NIES 4TH ADDITION WICHITA, SEDGWICK COUNTY, KANSAS

RE: SUB 2001-50 -- Final Plat of Nies Fourth Addition

At the regular meeting of the Subdivision Committee of the Metropolitan Area Planning Commission on Thursday, July 26, 2001, the above captioned plat was considered. The action of the Committee was to approve the final plat, subject to the following:

CASE NUMBER: SUB 2001-50 -- NIES FOURTH ADDITION

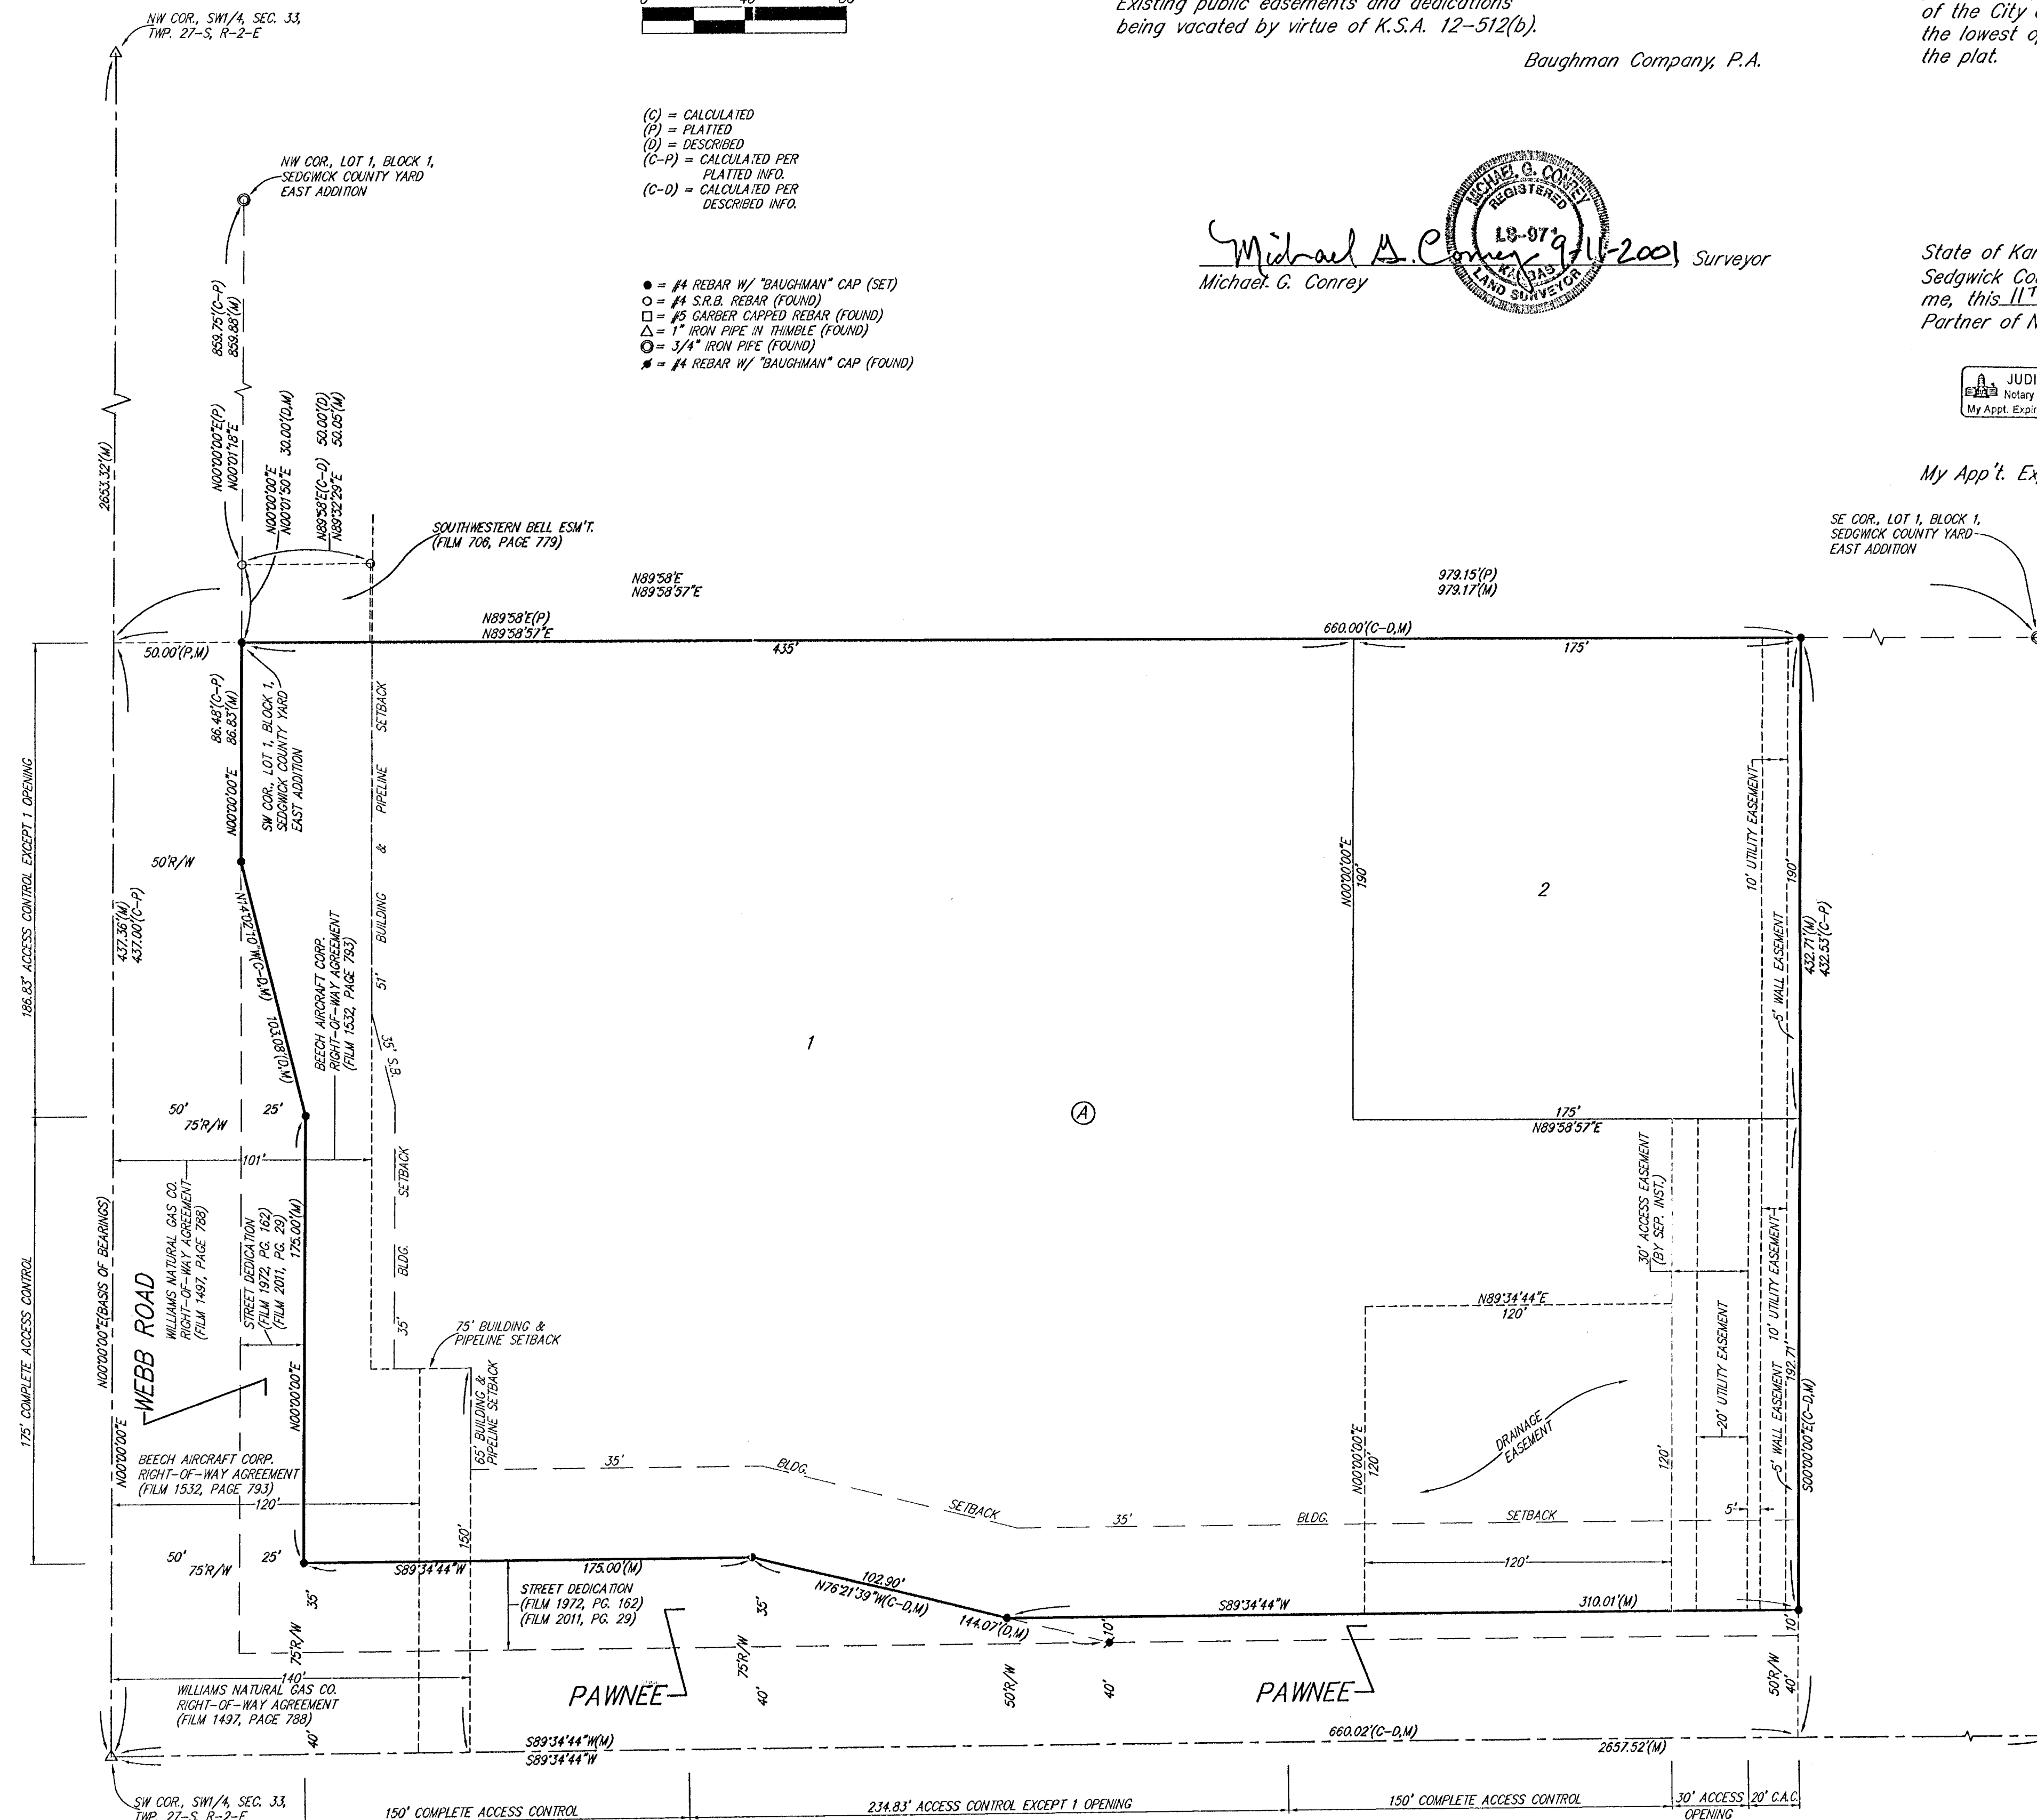
- C. City Water and Sewer Department has requested the platting of a private easement for utilities to extend a service line from Pawnee to Lot 2.
- D. If improvements are guaranteed by petition, a notarized certificate listing the petitions shall be submitted to the Planning department for recording.

- F. The plat proposes two access openings along Pawnee and one access opening along Webb. In accordance with the zone change, the access drive from Pawnee to Lot 2 shall be located at least 20 feet west of the east property line. 150 feet of complete access control is required along Pawnee from the intersection. Distances should be shown for all segments of access control. In accordance with the Subdivision regulations, any access openings located within

250 feet of the intersection of Pawnee and Webb are limited to right-turns only, and shall be referenced on the face of the plat; or a guarantee provided for the future construction of a raised medial. The final plat shall reference the access controls in the plat's text.

- H. The label at the northwest corner of the southwest $\frac{1}{4}$ needs to be corrected from "SW" to "NW".
- I. The wall easement needs to be referenced in the plat's text.

- J. "Pawnee Road" should be replaced with "Pawnee".
- K. A Protective Overlay Certificate shall be submitted to MAPD prior to City Council consideration, identifying the approved Protective Overlay and its special conditions for development on this property.
